Comments 1:

This paper carries out different numerical simulations to investigate the influence of different ground/soil structural changes (so called the seismic metamaterials according to this paper) around a wind turbine on the seismic wave-path between the wind turbine and the seismic station. It's a very interesting and meaningful research in the reviewer's opinion. The authors investigate four main types of different metamaterial scenarios including cross-shaped holes, half circular trenches at short distances, empty half circular trenches at large distances, and different topographic effects. The research is new, the discussion is insightful, and the English writing is clear and straightforward.

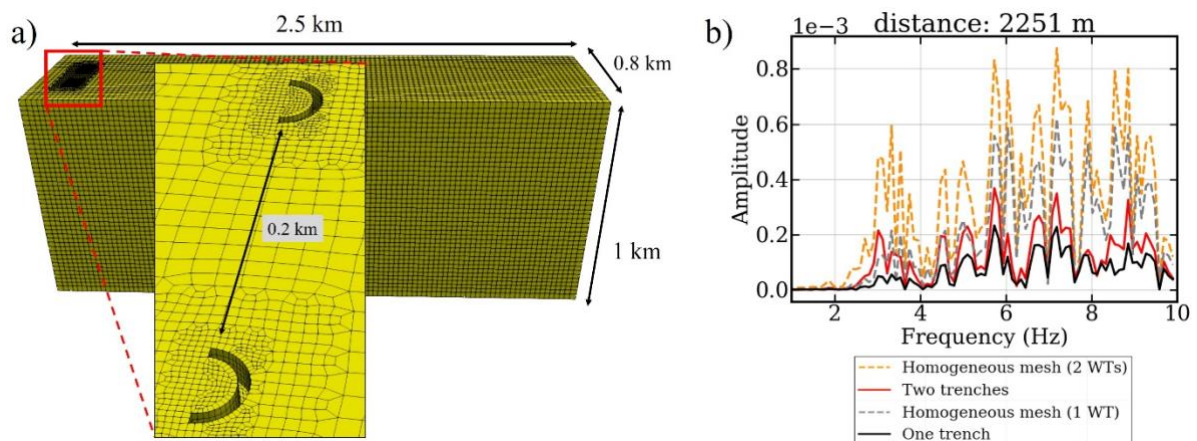
1. It seems this paper only studies the seismic signal emitted from one wind turbine. Will the investigated structural changes have similar influence on the seismic wave-path due to multiple wind turbines (or a wind farm)? It will probably make the research much more complex, but it may be worth discussing more, especially for the case of empty half circular trenches at large distances. Usually there is a wind farm at a large distance from a seismic station (or seismic stations).

R: In principle, it is expected that we will observe similar results for multiple WTs. The idea is to place the circular trench at each WT and in direction of the seismic station. The question, however, is how two wind turbines with two trenches would reduce the noise.

To answer this, we have created a new scenario where two WTs are placed separated by a distance of 200m. In front of each WT we place a circular trench of 5 x 15 m (width-depth). The numerical model has a total dimensions of 2.5 x 0.8 x 1 km (length-width-depth) and it has an increasing velocity with depth, just like in the previous scenarios. Results in the Fig. below show that we are still able to efficiently attenuate the seismic energy at large distance. We have added a paragraph in the main text.
